# Maps of OMA, TDP and mean power

Piers Dawe  
Mellanox Technologies

- Comments 140,141, 130, 129, 66, 70 and 18 relate to parameters average power, OMA, peak power and extinction ratio that are best discussed with the appropriate maps in view
- This presentation provides the maps and some discussion and recommendations

# Map of OMA vs. TDP

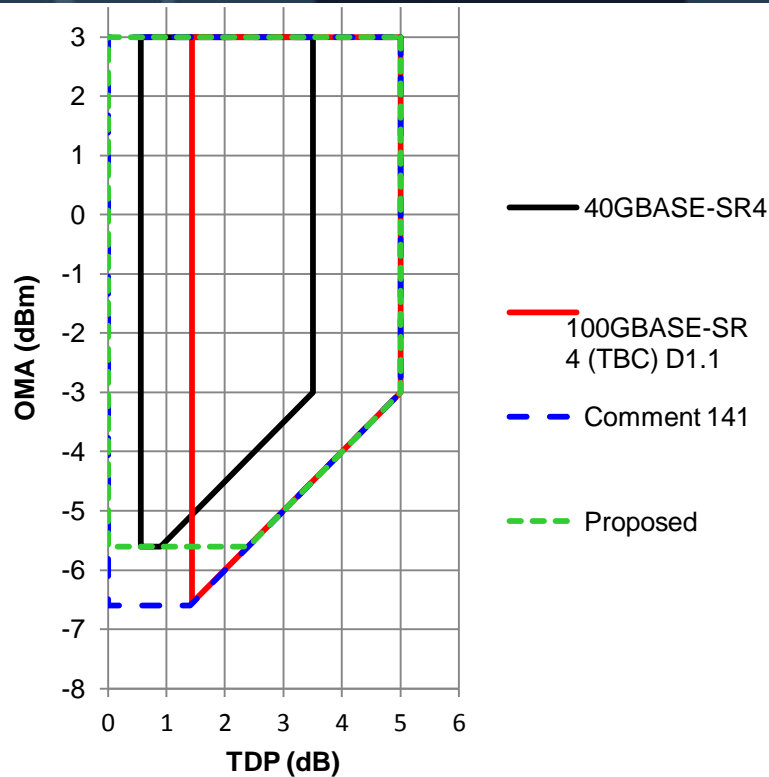
- Allowed Tx TDP and OMA in 40GBASE-SR4 and, for 100GBASE-SR4, in P802.3bm D1.1 (to be confirmed)
- Transmitter is not given credit for  $TDP < 0.9$  dB

- A noiseless Tx with 1 ps would have TDP of 0.44 dB for 40GBASE-SR4 and 0.76 dB for 100GBASE-SR4 (from spreadsheet model: ISI at decision timing offsets)
- For 12 ps, this becomes 0.56 dB or 1.44 dB (illustrated)
- TDP is not likely to be below 1.5 dB
- Cutoff line for TDP credit needs revision

- We should raise the minimum OMA for low-TDP Tx until there is a moderate flat region at the bottom
- Comment 141 proposed increasing the minimum OMA from -7.1 dBm to -6.6 dBm
- It turns out that isn't enough
- We might as well use the same limit as 40GBASE-SR4: -5.6 dBm
  - This makes operation and diagnostics of a mixed 40GBASE-SR4 / 100GBASE-SR4 network a little easier
  - No cost foreseen because this still offers an 8.4 dB high setup window for any future low-TDP transmitter

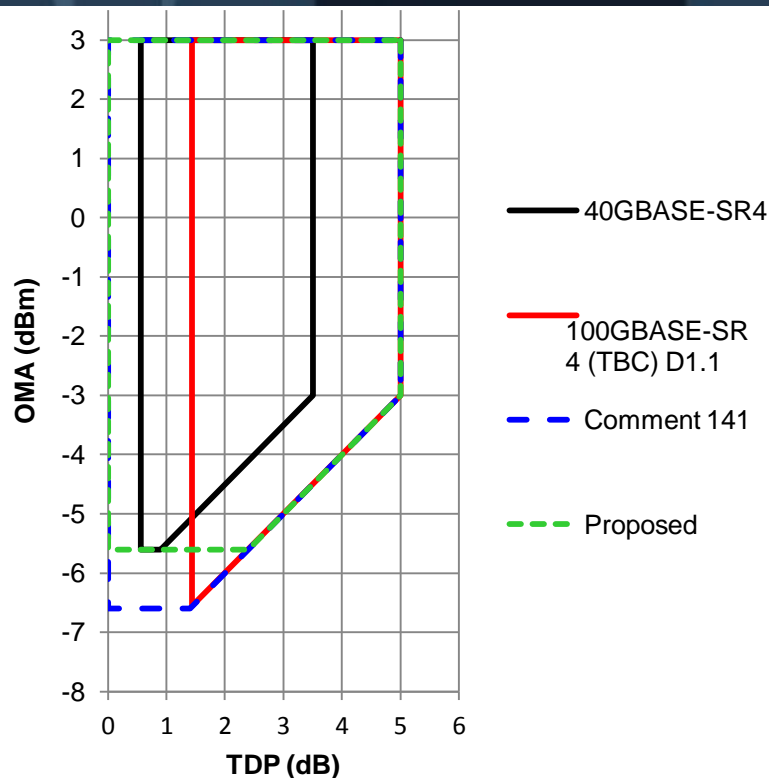
- Comment 18 proposes for Table 95–6, 100GBASE-SR4 transmit characteristics:
  - Insert note 'b' to spec line "Optical Modulation Amplitude (OMA), each lane (min)" : Even if the TDP < 0.9 dB, the OMA (min) must exceed this value.
- Instead of 0.9 dB, use 2.4 dB
- The minimum average power on each lane would also be increased
  - See next slide

# Difference between lanes

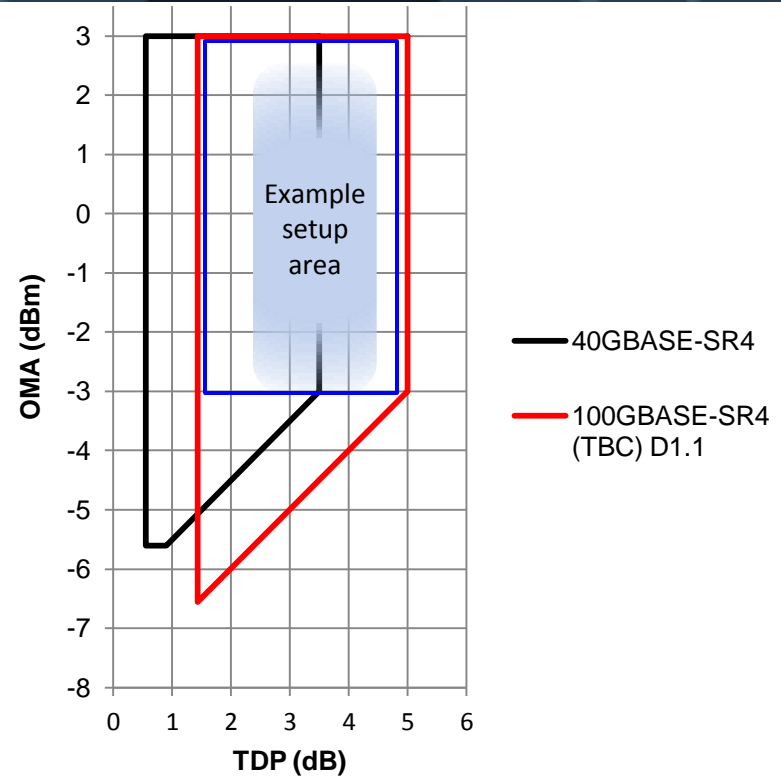
- Transmitters that make use of the maximum TDP spec can be set up by aiming within the blue rectangle
- Difference between max and min is 6 dB
  - Enough for setup
- This would also be the difference between any two lanes at the transmitter
- The difference at the receiver could be 1.9 dB more, because the loss of the lanes may not be equal
  - If the minimum attenuation is 0 dB/km
  - Total  $3 - (-3) + 1.9 = 7.9$  dB not  $3 - (-7.1) + 1.9 = 12$  dB (from slide 3)
- Use this to moderate the aggressor OMA in stressed receiver testing (comment 130)

# Choosing minimum average input power at receiver

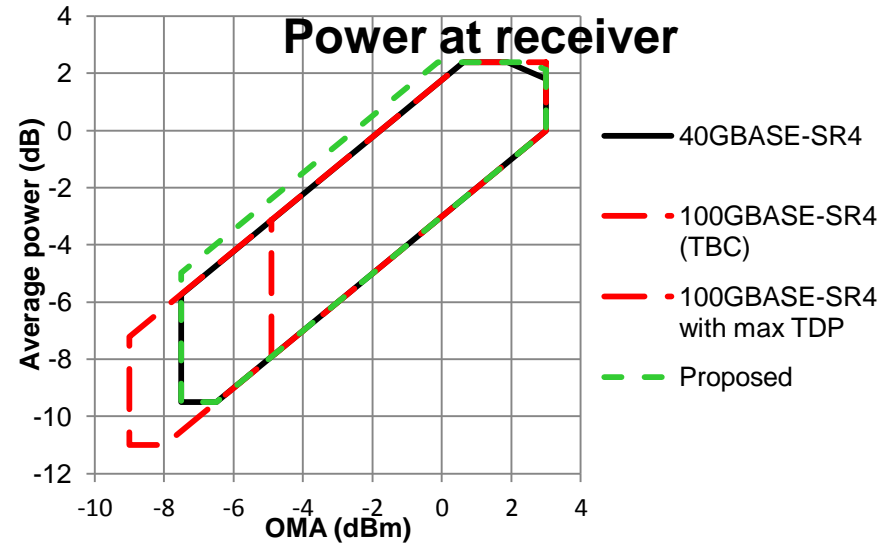
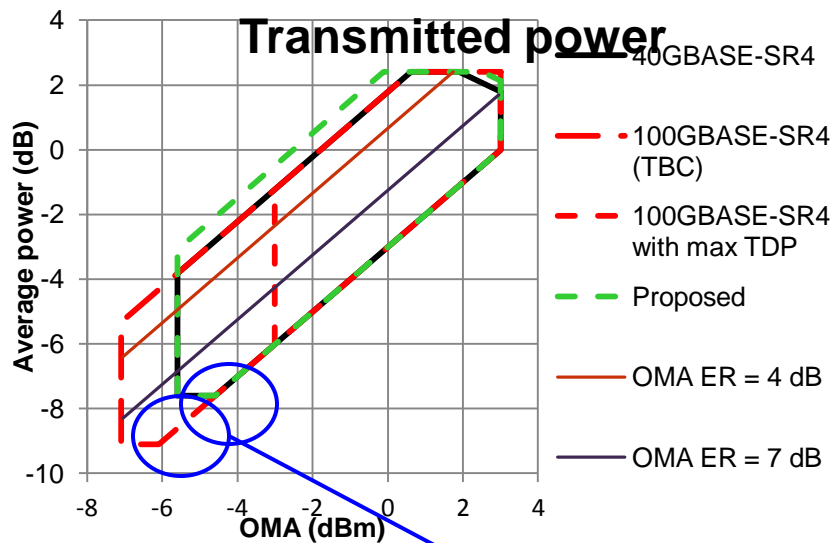
A directly modulated VCSEL is unlikely to have very high extinction ratio AND very low TDP

Power at receiver is 0 to 1.9 dB less than launch power

- Slide 4 shows that -5.6 dBm is a suitable Tx OMA minimum
- The draft -9.1 dBm minimum average launch power is unlikely to happen: it would need very high extinction ratio together with very low TDP
- -7.6 dBm, as in 40GBASE-SR4, looks suitable
- The minimum average input power at the receiver (TP3) would become -9.5 instead of -11 dBm
- Note: these maps assume that all ones and zeros are the same
  - No distinction between "OMA extinction ratio" and "SONET extinction ratio"
  - Peak power calculated as average power in ones – true peak can be higher because of overshoot

# Revisiting minimum extinction ratio

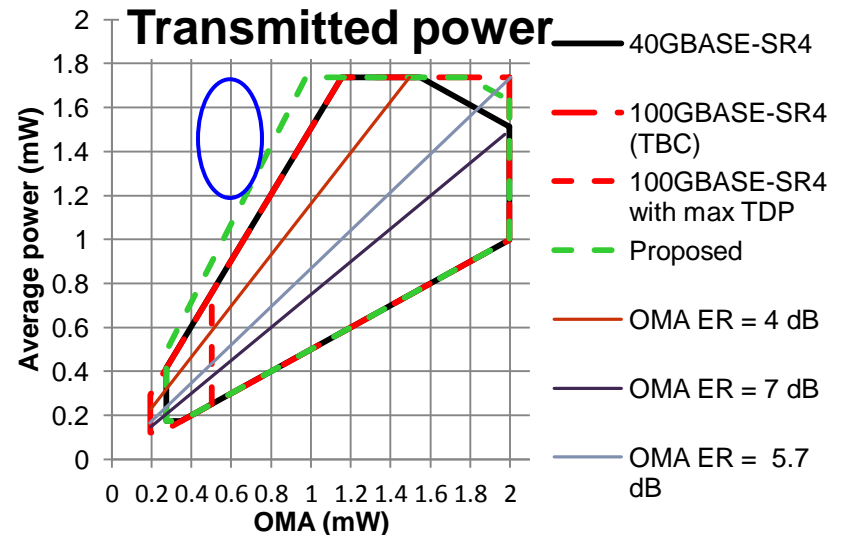
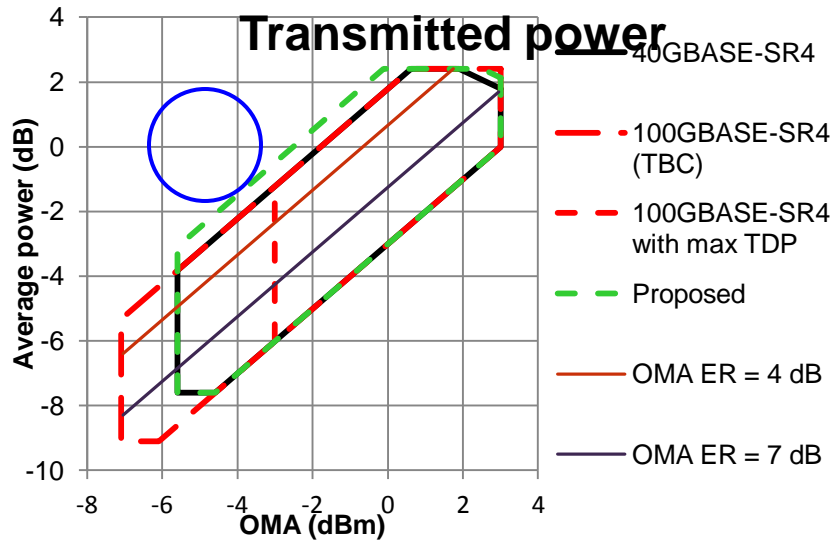
- For a relatively slow transmitter, "SONET extinction ratio" (as in 10G/40G/100G Ethernet as well as SONET and SDH) is lower than "OMA extinction ratio"
- Current draft spec is 3 dB minimum. Comment 66 and 70 criticise this
- Circled regions would have a very high ratio of average power to OMA (DC photocurrent to modulated photocurrent) which would put an unnecessary burden on the receiver's DC cancellation feedback loop (or equivalent)
- However, it may be advisable to relax the spec moderately, to 2.5 dB
- Note: in the plot on the right, straight lines are drawn between calculated vertices. If the intermediate points were calculated, the lines would be slightly curved

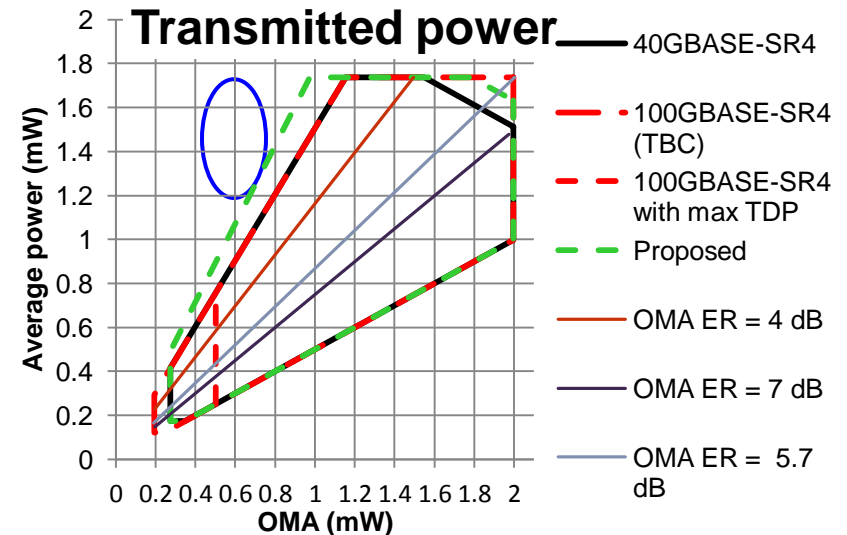
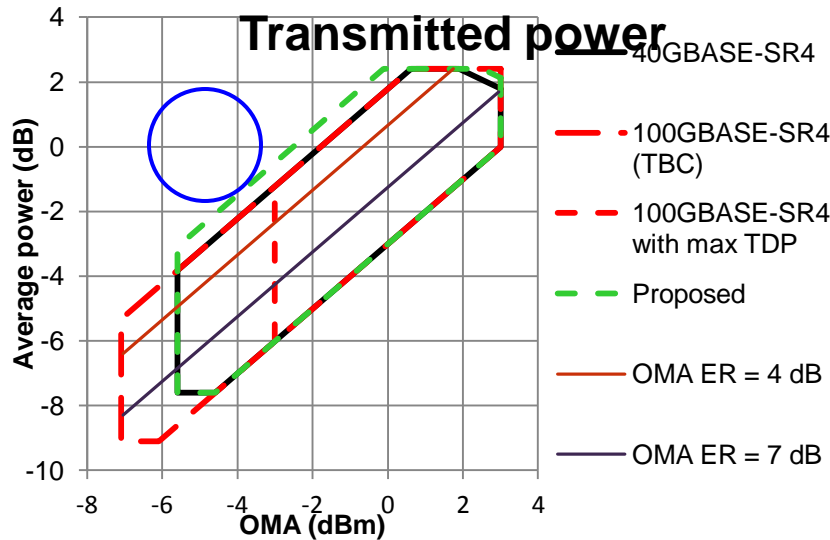
- 40GBASE-SR4 has a peak power limit of 4 dBm or 2.5 mW to protect the receiver from excessive photocurrent
- Without this, the peak power could be 4.37 dBm plus 0.8 dB or 20% higher because of overshoot, giving about 4.8 dBm or 3 mW
- A transmitter would have to have high overshoot AND a particular extinction ratio to create this peak power
- A maximum peak power spec protects the receiver at little to no inconvenience to the transmitter
- The limit should be a little higher than 40GBASE-SR4's 4 dBm
- Comment 129 proposes 4.2 dB, as illustrated

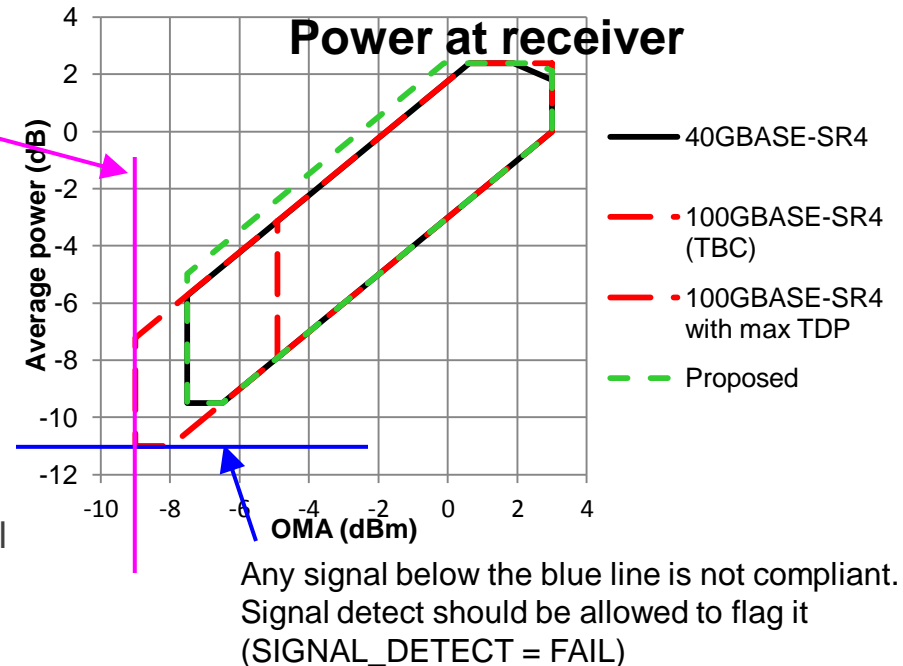
Any signal to the left of the magenta line is not compliant. Signal detect should be allowed to flag it (SIGNAL\_DETECT = FAIL)

- Signal detect must detect a compliant signal: one that is to the right of the magenta line, above the blue line, and 100GBASE-SR compliant (pattern).
  - It doesn't have to check all these things
- Signal detect should be allowed to flag any non-compliant signal as non-compliant
  - It doesn't have to do so, unless the average optical power at the receiver (TP3) is -30 dBm or less
- Comment 140:
- Change
  - [(Optical power at TP3  $\geq$  average receive power, each lane (min) in Table 95-7)
  - AND
  - (compliant 100GBASE-R signal input)]
- to
  - Compliant 100GBASE-R signal input at TP3 with OMA  $\geq$  -9 dBm and average optical
  - power  $\geq$  average receive power, each lane (min) in Table 95-7
    - (-9 would become -8.5 if another comment is accepted).
